Project	IEEE 802.16 Broadband Wireless Access Working Group < http://ieee802.org/16 >
Title	BS to BS Time Synchronization Support, for OFDMA PHY mode
Date Submitted	2004-07-07
Source(s)	Yong Chang, Geunhwi Lim, Hong Sung Chang, JungWon Kim, TaeWon Kim Samsung Electronics Co. Ltd. yongchang@samsung.com
Re:	A detailed operation scenario are added to adopt reply comment
Abstract	BS to BS Time Synchronization Support, for OFDMA PHY mode
Purpose	Adoption of proposed changes into P802.16e /D3-2004
Notice	This document has been prepared to assist IEEE 802.16. It is offered as a basis for discussion and is not binding on the contributing individual(s) or organization(s). The material in this document is subject to change in form and content after further study. The contributor(s) reserve(s) the right to add, amend or withdraw material contained herein.
Release	The contributor grants a free, irrevocable license to the IEEE to incorporate material contained in this contribution, and any modifications thereof, in the creation of an IEEE Standards publication; to copyright in the IEEE's name any IEEE Standards publication even though it may include portions of this contribution; and at the IEE

Figure ??. Initial BS-BS Time Synchronization

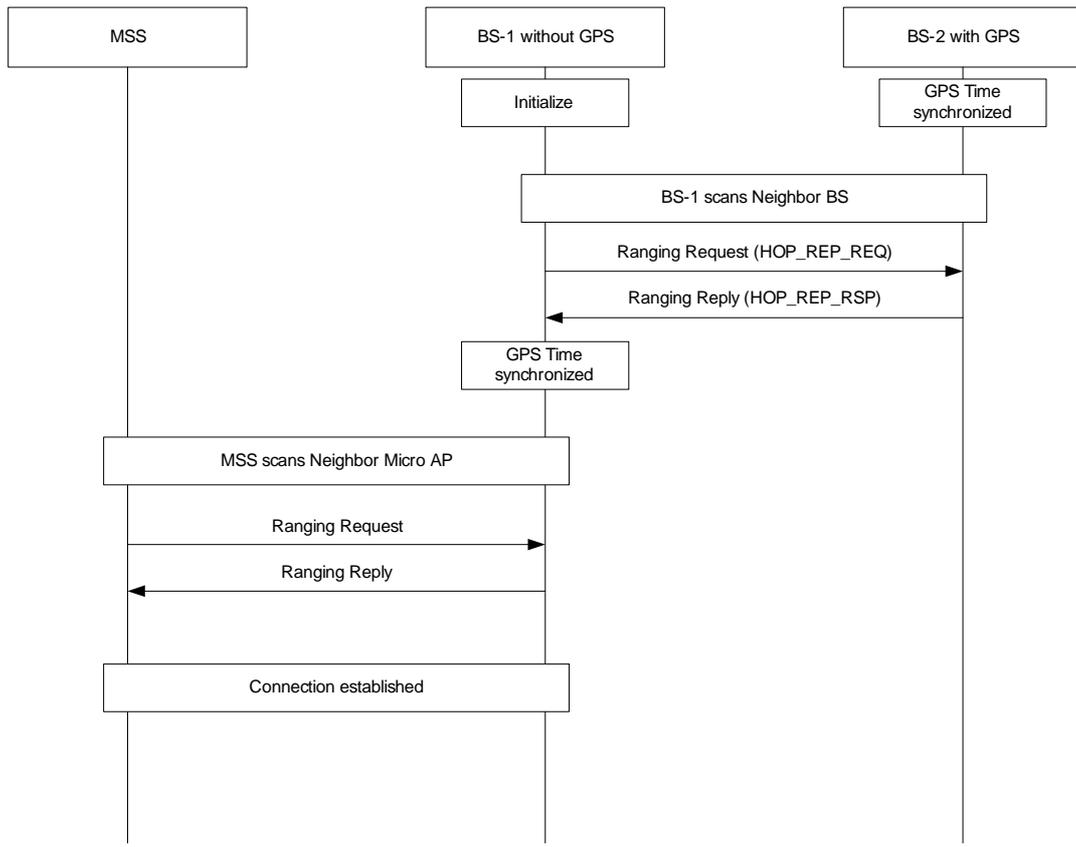
[In page 105, add the following section]

Time synchronization is required to operate with frequency reuse factor of 1 in the current OFDMA system. Time synchronization between BS can be usually achieved by GPS. But, GPS module is expensive and it's hard to receive GPS signals in indoors. Without GPS receiver, a small BS may achieve time synchronization with other GPS equipped BS via AIR signal such as Ranging.

Because the BS should periodically calibrate the internal clock to maintain the time synchronization, BS should periodically perform ranging operation in MSS mode and all MSS attached to the BS should not access the BS during the period. Hence, DCD message from a BS may include TLV to indicate the time and duration when the BS performs clock calibration.

6.3.18.1 BS-BS Time Synchronization Operation Scenario

Figure ??. Periodic BS-BS Time Synchronization

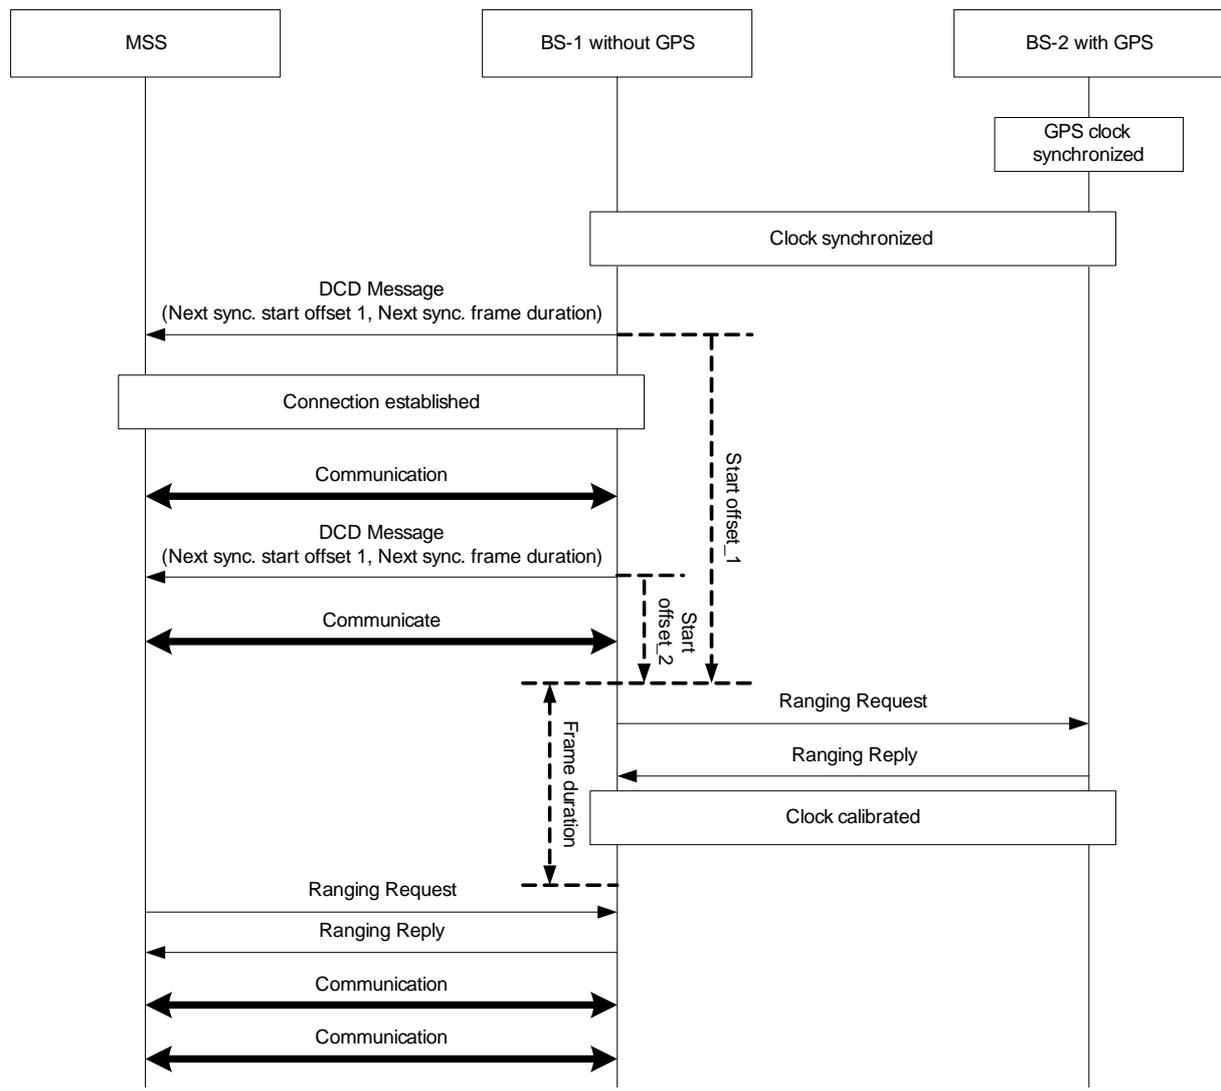
Hence, ranging message may include TLV to indicate the accuracy of the time synchronization provided by the BS.
